**Document title: SNL Responses to Public Comments and Citizen Action  
Comments on the Mixed Waste Landfill Corrective Measures  
Implementation Plan, April 2006**

**SNL RESPONSE TO PUBLIC COMMENTS  
AND CITIZEN ACTION COMMENTS  
ON THE  
MIXED WASTE LANDFILL  
CORRECTIVE MEASURES IMPLEMENTATION PLAN**

**Review of Sandia National Laboratories'  
Mixed Waste Landfill Corrective Measure Implementation Plan  
and  
Fate and Transport Model:  
Comments and Recommendations**

Figure 22. Simulated PCE groundwater concentrations for 100 realizations.

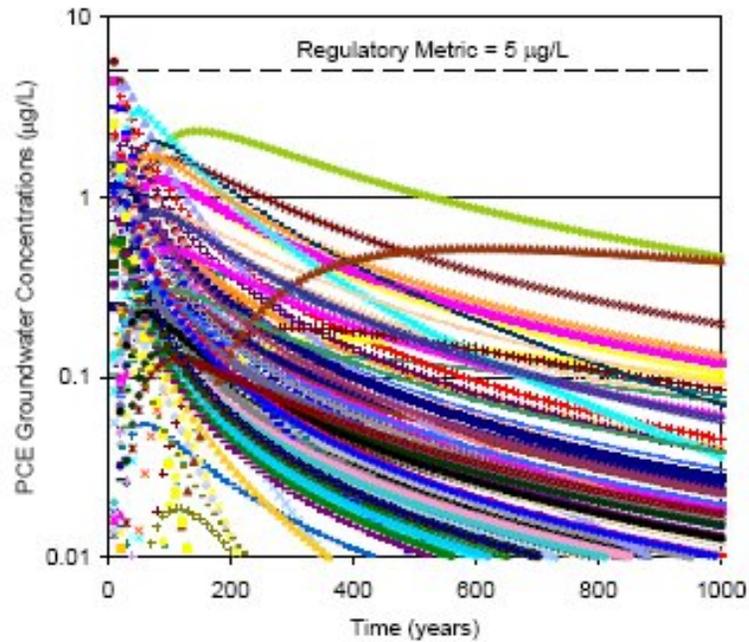
The FTM states: "Figure 22 [on p. 55] shows the simulated PCE concentrations in the groundwater as a function of time for all 100 realizations. **The majority of the realizations show the aquifer concentrations peaking before 50 years. Depending on the time of disposal, this corresponds to peak concentrations occurring by 2010 – 2040.** [emphasis added]. To date, no detectable amounts of PCE have been found in the groundwater at the MWL. This is still consistent with the simulations which show a large amount of variability in the simulated concentrations resulting from uncertainty included in the input parameters." FTM at pp. 54-55. Figure 22 is attached these comments as APPENDIX A.

Figure 23. Cumulative probability for simulated PCE peak groundwater concentrations for 100 realizations.

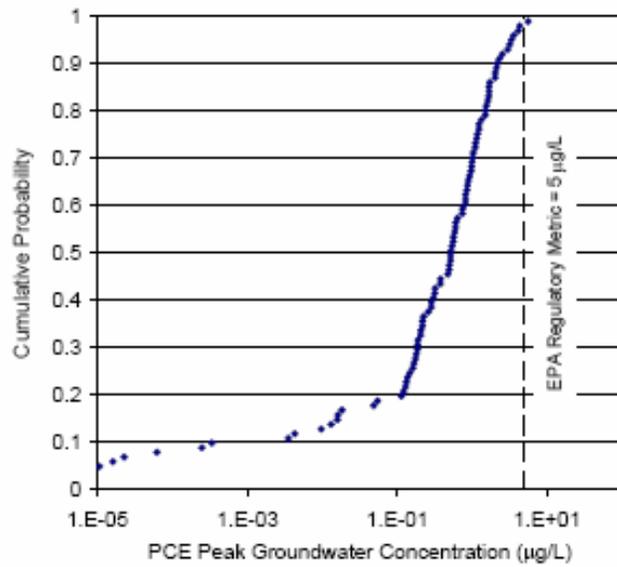
Figure 23 in the FTM shows the concentration of PCE anticipated in the groundwater by the model realizations. This figure shows that the vast majority of the realizations – about 80% - show PCE levels in the groundwater in the range of 1 – 5 micrograms per liter, equivalent to parts per billion. Prediction of those concentrations of PCE reaching the groundwater represent a prediction of significant contamination as PCE is not naturally occurring and therefore **zero** PCE would be predicted to have reached groundwater if no PCE were already shown to have escaped from the MWL. Figure 23 is attached to these comments in APPENDIX A.

*SNL Response: In contrast to the statement above, only 30% (not 80%) of the realizations results in groundwater concentrations ranging from 1 – 5 micrograms per liter. Only 1% of all the realizations show a groundwater concentration that exceeds the regulatory metric of 5 micrograms per liter.*
